UNITED STATES
NUCLEAR REGULATORY COMMISSION
WASHINGTON, D.C. 20555-0001

SUBJECT: TECHNICAL REVIEW OF REAL WASTE RELEASE TESTING
RESULTS FOR TANK 18F AND ASSOCIATED PERFORMANCE
ASSESSMENT DOCUMENTATION FOR F-AREA AND H-AREA
TANK FARM FACILITIES AT SAVANNAH RIVER SITE, AIKEN,
SOUTH CAROLINA (DOCKET NO. PROJ0734)

Technical Review of Real Waste Release
Testing Results and Associated Performance
Assessment Documentation

Technical Review of Real Waste Release Testing Results and Associated Performance Assessment Documentation

Figure 1. FTF Dose for Four Different Pu Solubilities

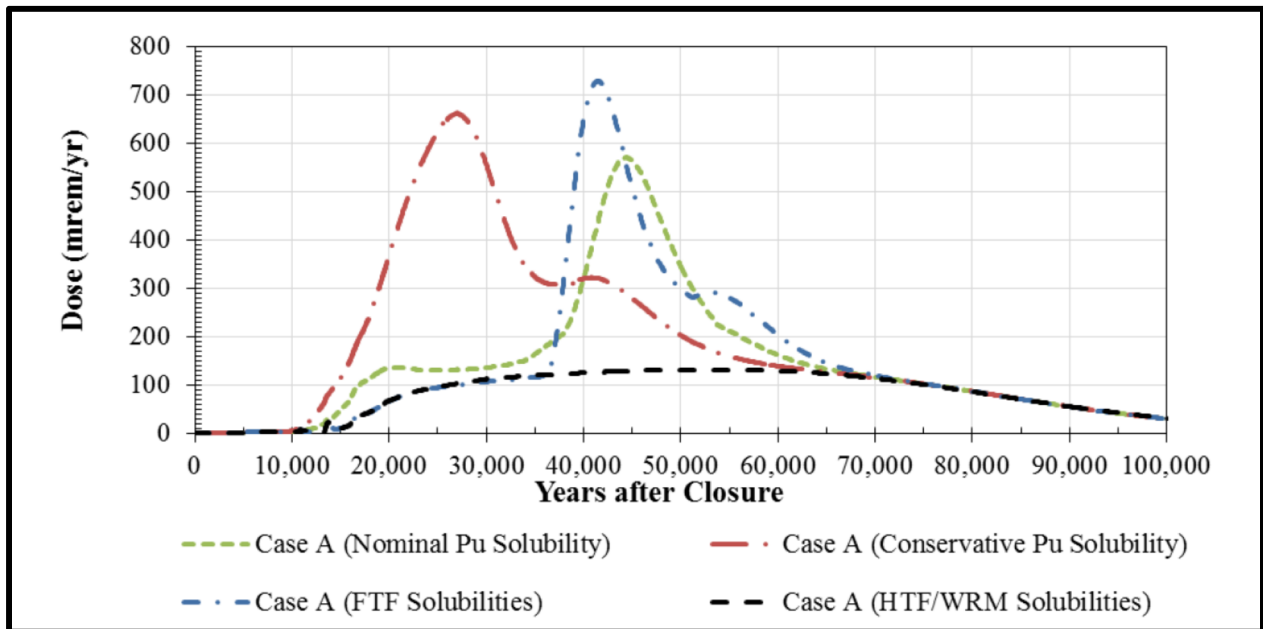
- DOE should explain differences in PORFLOW and GoldSim modeling results (e.g., Pu peak doses of around 5 mSv/yr (500 mrem/yr) in the Tanks 18/19 SA (SRR-CWDA-2010-00124) versus 7 mSv/yr (700 mrem/yr) in SRR-CWDA-2016-00086).

A peak dose ranging from approximately 1 to 7 mSv/yr (100 to 700 mrem/yr) results depending on the assumed solubility of Pu (see Figure 1). Additionally, the timing of the peak dose varies tens of thousands of years (e.g., "conservative" case versus "nominal" or "HTF" case) depending in large part on whether risk-significant solubilities are assumed initially or later in time, demonstrating again the importance of chemical barrier performance on the results⁶.

⁶ It is important to note that the results presented in Figure 1 were based on GoldSim modeling reported in SRR-CWDA-2016-00086, while the results reported in the FTF PA (SRS-REG-2007-00002, Rev. 1) and Tanks 18F and 19F SA (SRR-CWDA-2010-00124) are based on PORFLOW modeling, leading to differences in the reported peak doses with GoldSim typically resulting in higher peak doses compared to PORFLOW. Additionally, following preparation of the FTF PA, a higher, final estimated Pu inventory was developed for use in the Tanks 18F and 19F SA. The higher estimated Pu inventory was based on actual residual waste sampling following waste retrieval.

Figure 4. NRC Staff's Interpretation of Performance of Barriers to Timing of Peak Dose in DOE's FTF PA. Adapted from Figure 3-5 in the Tank Farms Monitoring Plan (ML15238A761).

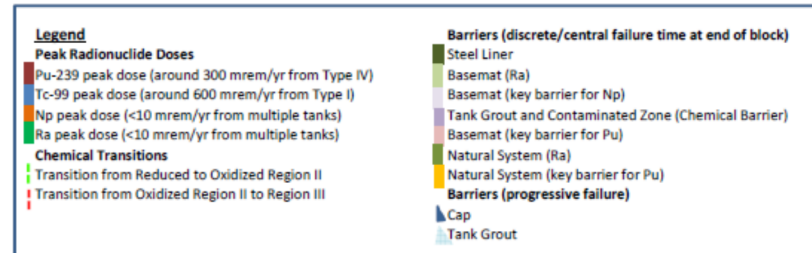
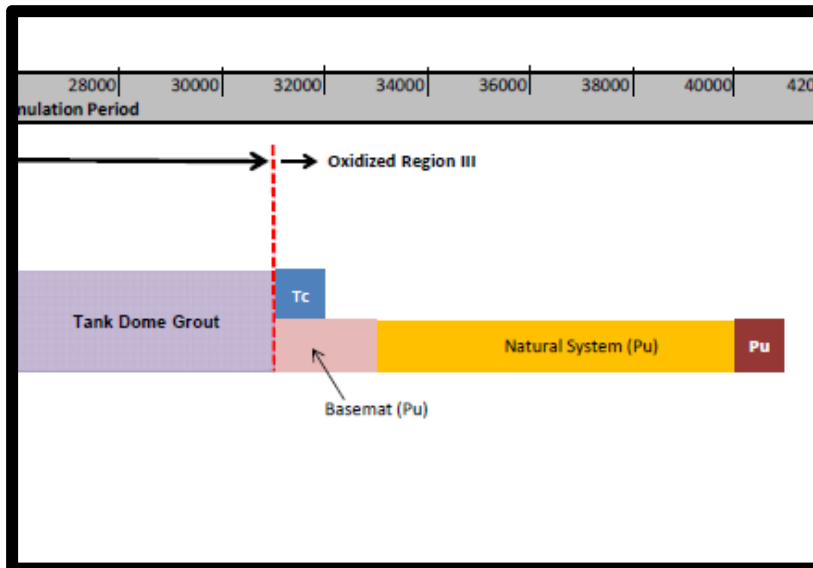
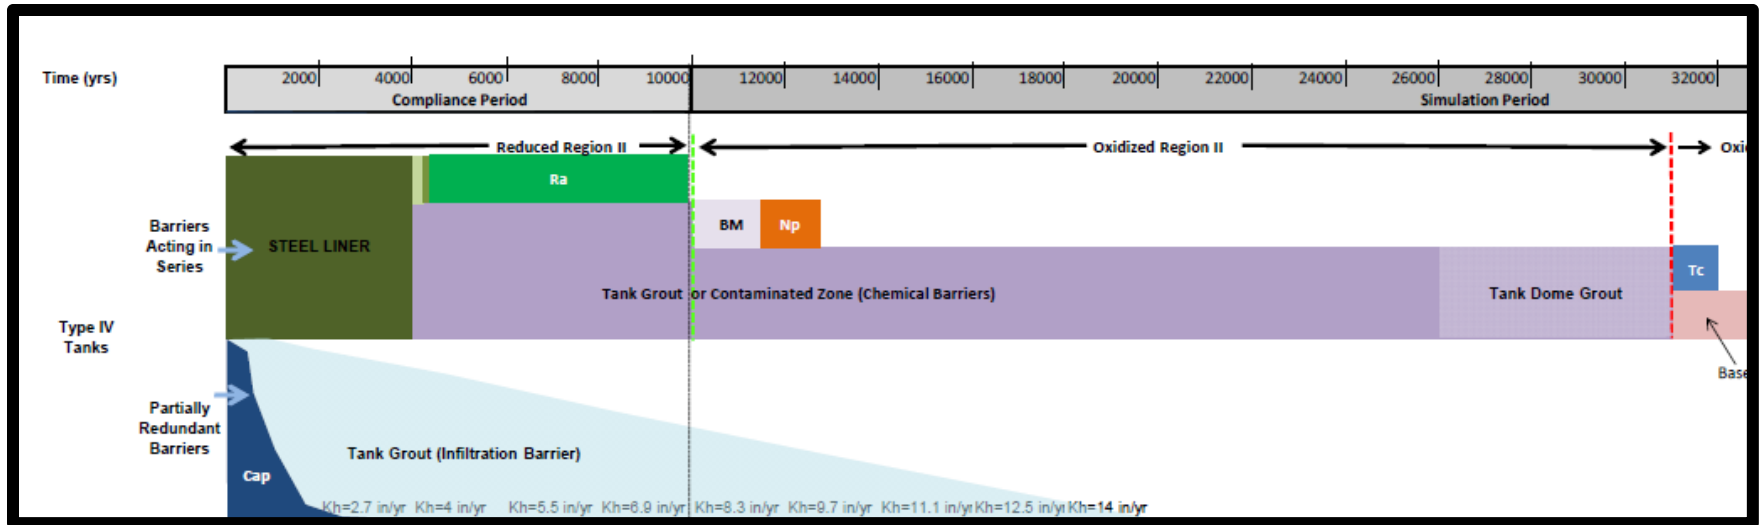
Figures 3 and 4 (see green and red dashed, vertical lines in Figure 4) illustrate the two transition times between the three grout degradation periods at which time E_h and pH markedly change, and the resulting three chemical regimes assumed in the FTF PA for Type IV tanks, such as Tank 18F. Figure 3 presents additional details regarding the assumed phases controlling Pu solubility, as well as the assumed chemistry of the groundwater in contact with grout solids. Table 7 presents information on the assumed chemical transition times in the HTF PA in comparison to the FTF PA. With the exception of the iron (Fe) coprecipitation column listed in Table 6, the Pu solubilities are assumed to either stay the same or increase with time. As can be seen in these figures and tables, DOE oftentimes relies on the chemical performance of the tank grout for tens of thousands of years. Therefore, the timing of chemical transitions to higher solubility are oftentimes risk-significant in DOE's PAs. Uncertainty in chemical transition times are addressed in NRC staff's Monitoring Plan under MFs 2.2, "Chemical Transition times," and 3.2, "Groundwater Conditioning via Reducing Grout" (ML15238B403).

Additionally, Figure 4 illustrates the importance of the steel liner, basemat, and natural system in delaying the timing of peak dose from Pu. Uncertainty in steel liner performance is addressed in NRC staff's monitoring plan, MF 3.1, "Hydraulic Performance of Concrete Vault and Annulus (As it Relates to Steel Liner Corrosion and Waste Release)." Uncertainty in basemat performance is addressed by MF 3.5, "Vault and Annulus Sorption." And uncertainty in natural system performance is addressed by MF 4.1, "Natural Attenuation of Key Radionuclides". While awaiting the results of the waste release experiments which addressed NRC staff's highest priority MF 2.1, "Solubility Limiting Phases/Limits and Validation", DOE has not yet addressed these other high priority MFs⁵.

Figure 5 Location of Sample FTF-1 and Distribution of Residual Waste in Tank 18F

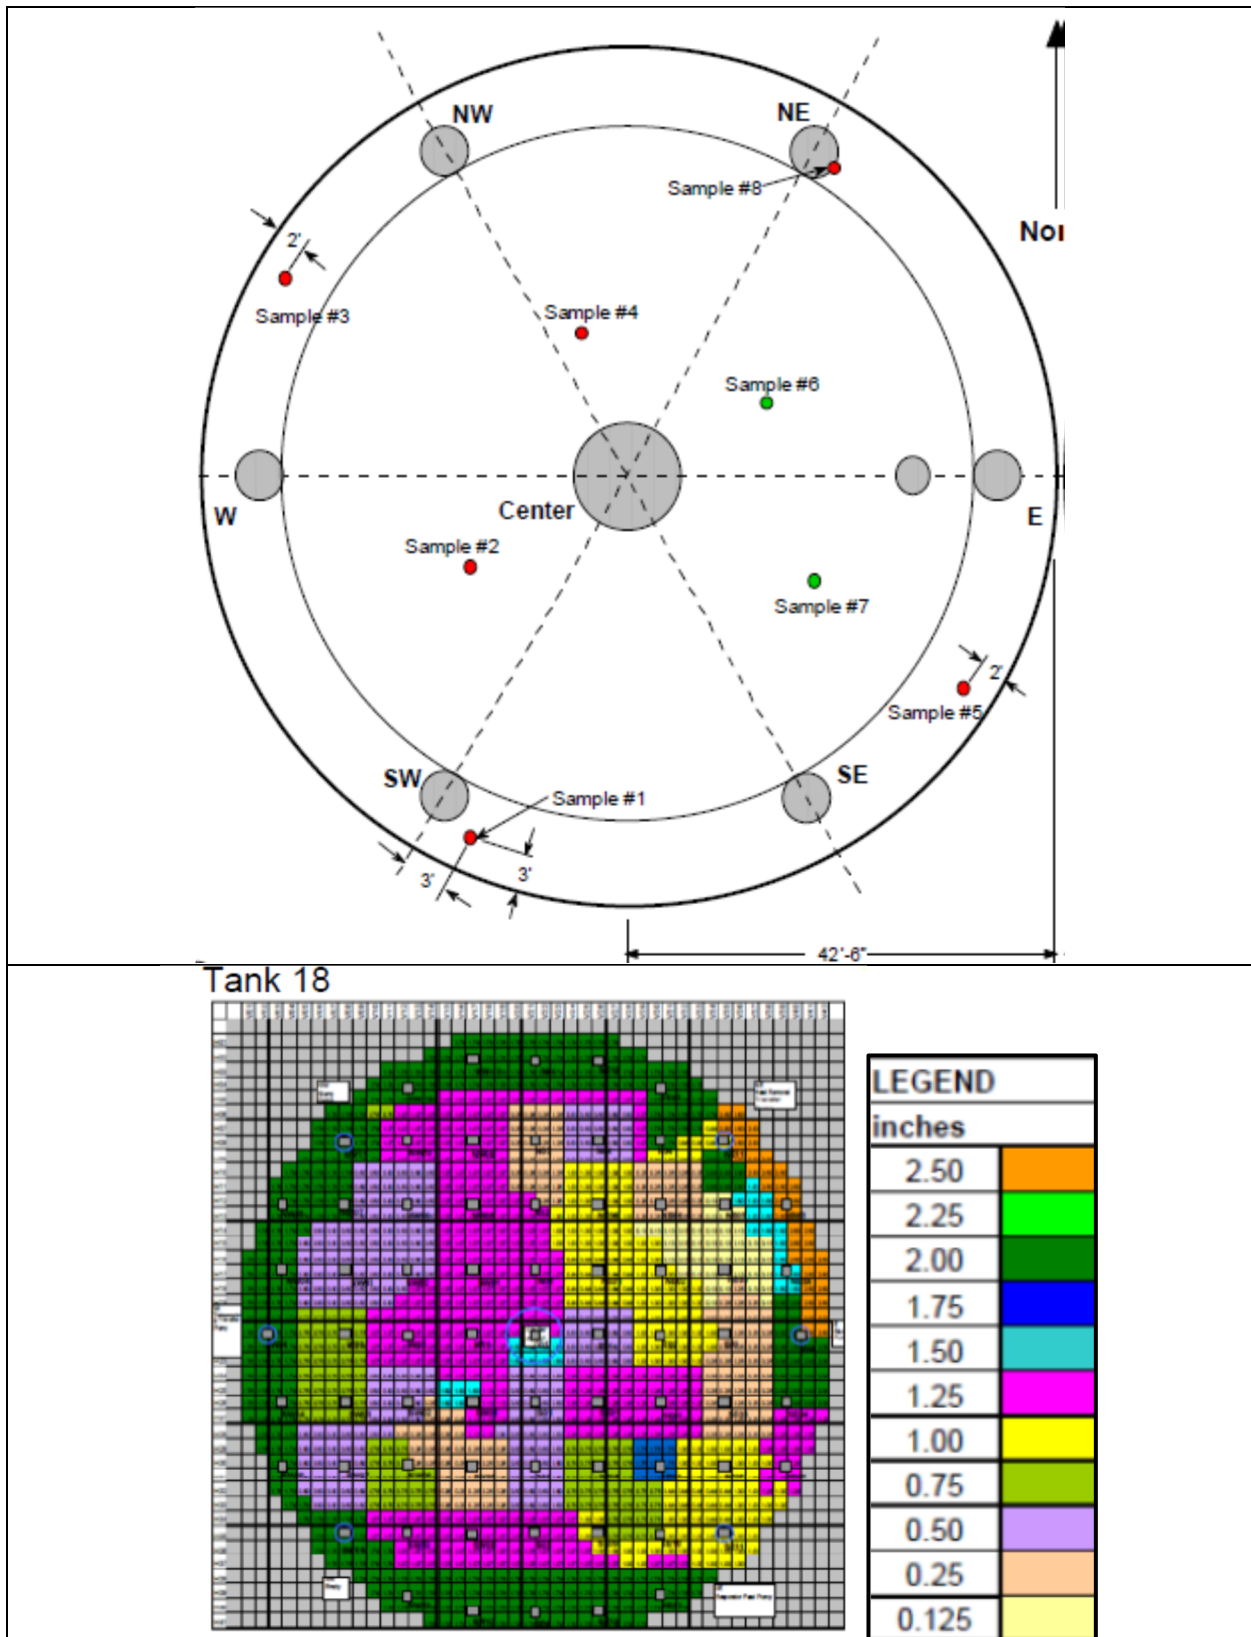
- Although DOE only used a single sample (FTF-1) for the Tank 18F waste release testing, their rationale (e.g., good characterization, and high concentrations of key radionuclides) is reasonable. In future waste release testing, if testing of multiple samples is impractical, DOE should consider compositing samples to get representative results for the entire tank contents rather than just a small portion of the waste.

Figure 6. Pu Concentrations versus Time for ORII and ORIII Experiments (Reproduced from Figure 3-5 of SRNL-STI-2016-00432, Rev. 0)

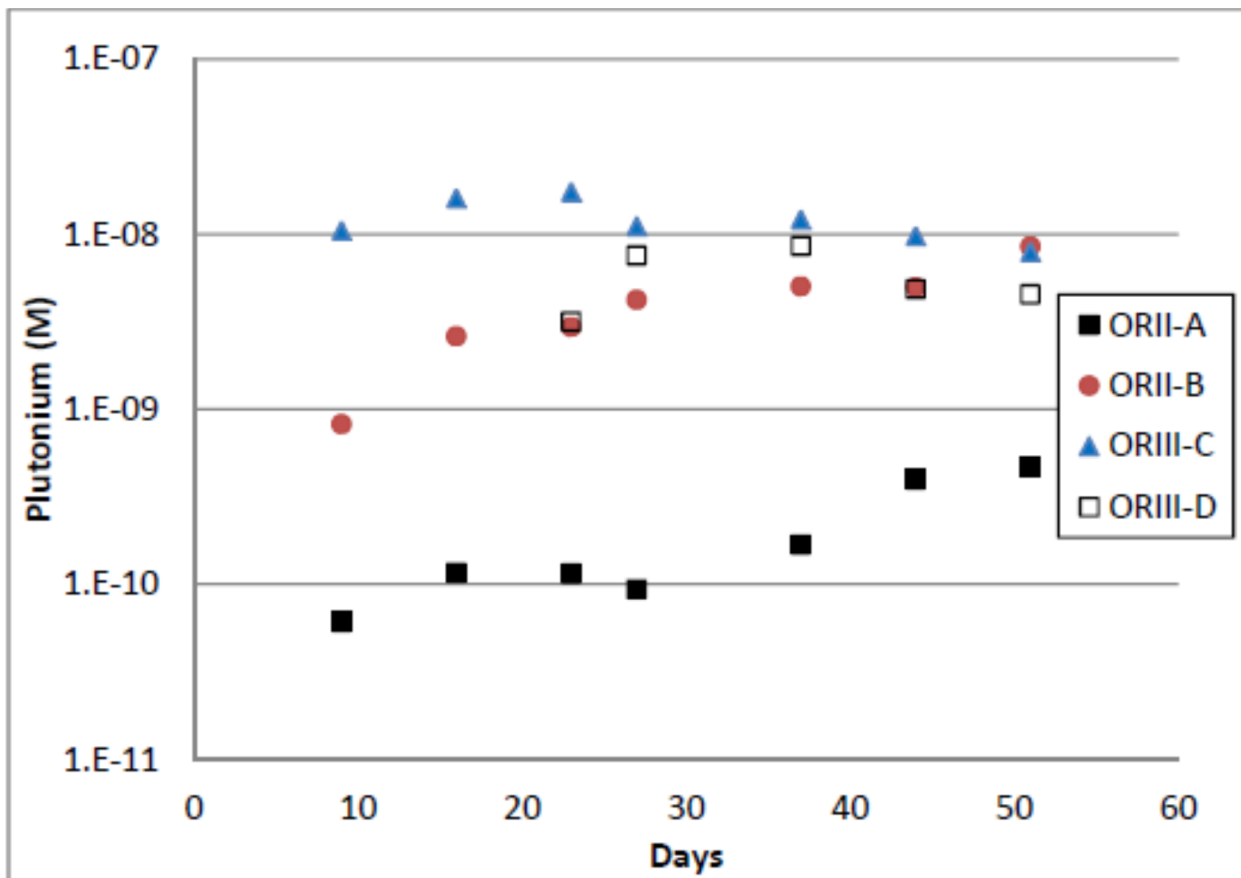
Observations of leachate radionuclide concentrations with time suggested that steady-state values were often not obtained. For example, plutonium concentrations were still increasing at the end of the ORII tests (Figure 3-5 of SRNL-STI-2016-00432). Tc concentrations increased throughout all oxidizing tests (Figure 3-9 of SRNL-STI-2016-00432). These patterns suggest that reported concentrations may underestimate the potential leachate concentrations.

As shown in Figure 3-5 of SRNL-STI-2016-00432, Pu concentrations were still increasing at the end of the ORII experiments (see Figure 6). A gradual increase in Pu concentration with time was observed for both ORII test samples, and based on the data, it is uncertain whether saturation and equilibrium were achieved during the test period. In addition, the Pu concentrations observed for the ORII-A sample were consistently an order of magnitude lower than for the ORII-B samples. This difference is not understood, because nearly identical sample preparation methods and amounts were used for each. Plutonium concentrations observed for the ORIII test samples (C and D) were more stable and were typically the highest values observed (near 1×10^{-8} M) of any samples tested. Due to the gradual increases observed for the ORII-B samples, the final sample analyzed was also near 1×10^{-8} M. The Pu concentration results still exhibit a significant level of uncertainty, and indicate a complexity not easily captured in a model using a single solubility value to represent the contaminated zone at each time step. It is possible that the Pu results reflect the fact that the residual sample includes two or more types of Pu with differing solubilities. The differing solubilities could be associated with oxidation state, chemical speciation, or matrix differences. For example, a significant fraction of the Pu in the sample could be coprecipitated with other metals present in the residual solids or imbedded deep within the solid matrix (SRNL-STI-2016-00432). Inability to achieve steady state concentrations can also be seen on ORII-B U results and in all Tc results. The investigators should explore approaches to resolving the lack of steady-state observations and provide justification for use of the results in PA modeling.

- Inability to achieve equilibrium concentrations at the end of ORII tests for Pu and the discrepant final concentrations for Pu in the two different ORII test results demonstrate the level of complexity involved when modeling Pu release. Additional work to address uncertainty in Pu solubility would be beneficial.

Figure 8 Peak Dose versus Time for Various Assumed Pu Solubilities. Taken from SRR-CWDA-2010-00124, Figure 6.3-23.

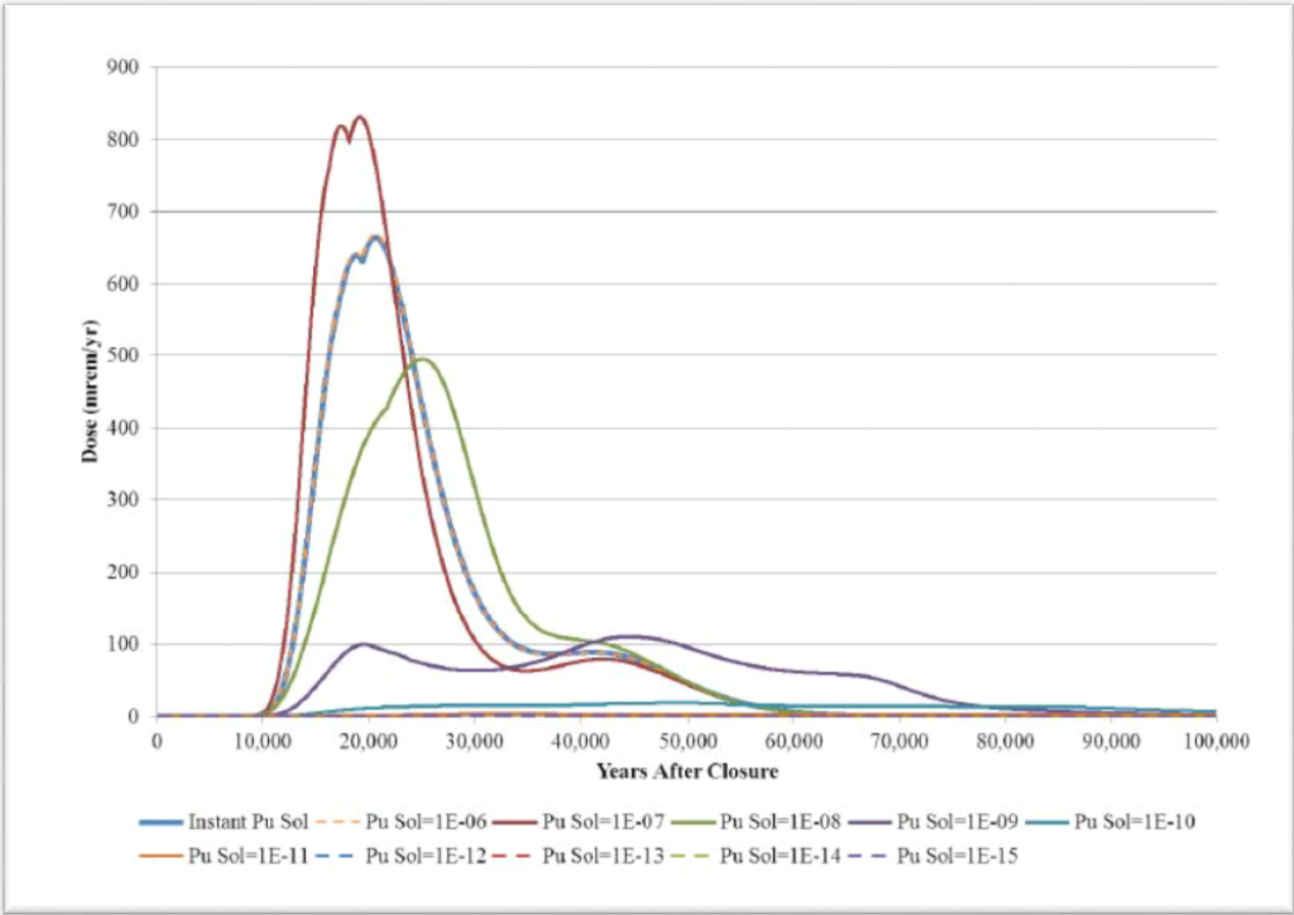
As discussed above, the results of the Tank 18F waste release testing indicate that the solubility of Pu is risk-significant at the time of tank closure. Previous simulations conducted by DOE showed that when the assumed solubility occurs at time $t = 0$ years and is held constant, the highest doses occur when the solubility is approximately $1E-07$ mol/L (see Figure 8). However, the peak dose is lower with an assumed solubility of $1E-06$ mol/L, which is an order of magnitude lower than the highest assumed solubility of $1E-07$ mol/L. This counter-intuitive result occurs due to the transport of Pu into the tank grout overlying the waste zone early during the simulation period. After the steel liner fails thousands of years later (and water flow through the system increases), Pu is transported vertically downward out of the engineered system, but at lower concentrations than would occur if the Pu did not migrate into the overlying tank grout early on in the simulation. Scoping calculations performed by NRC staff show that if the steel liner and tank grout does not perform as well as assumed in the base case (see Figure 4, which indicates DOE gets credit for tank grout performance for thousands of years), then the Pu release rates could be significantly higher (e.g., the release rates could be $5\times$ higher if the full flow rates are realized after 500 years). These scoping calculations demonstrate the importance of assumptions regarding the conceptual model for fluid flow through the system and the assumptions regarding engineered barrier performance in DOE's base case PA (e.g., MFs 3.1, and 3.2 [ML15238A761]).

Although the DOE simulations are instructive on the impact of initial Pu solubility on peak dose, the simulations do not show the importance of other barrier assumptions on the results. For example, the impact of basemat bypass and impact of natural system K_d on timing of peak dose was not evaluated in SRR-CWDA-2016-00086. If ground water bypasses the attenuating capacity of the basemat, and a fraction of the waste has a low K_d of 3 L/kg (Demirkanli et al., 2007) the Pu peak dose could occur much earlier in time, and be above the performance objective within 10,000 years. MFs related to vault and natural system performance (MF 3.5 "Vault and Annulus Sorption" and MF 4.1 "Natural Attenuation of Key Radionuclides") are important because if the basemat and natural system do not perform as well as assumed in the PA, the peak release will occur earlier in time and the dose could be above the performance objectives within the compliance period. Scoping calculations show that if 100 percent of the mobile fraction is assumed, and basemat bypass occurs (and full flow occurs early during the simulation at 500 years), the peak dose could be orders of magnitude higher than the performance objective significantly earlier in time (well within 10,000 years and potentially within 1000 years). While this case is not realistic, it points to the fact that only a small fraction of high mobility Pu can be present and still meet the performance objectives. Additionally, alternative conceptual models that would hasten the time to peak dose (e.g., groundwater table rise and basement bypass) are also risk-significant. Thus, the extent which high mobility forms of Pu exist in SRS groundwater, as well as the stability of these high mobility forms¹¹, should be
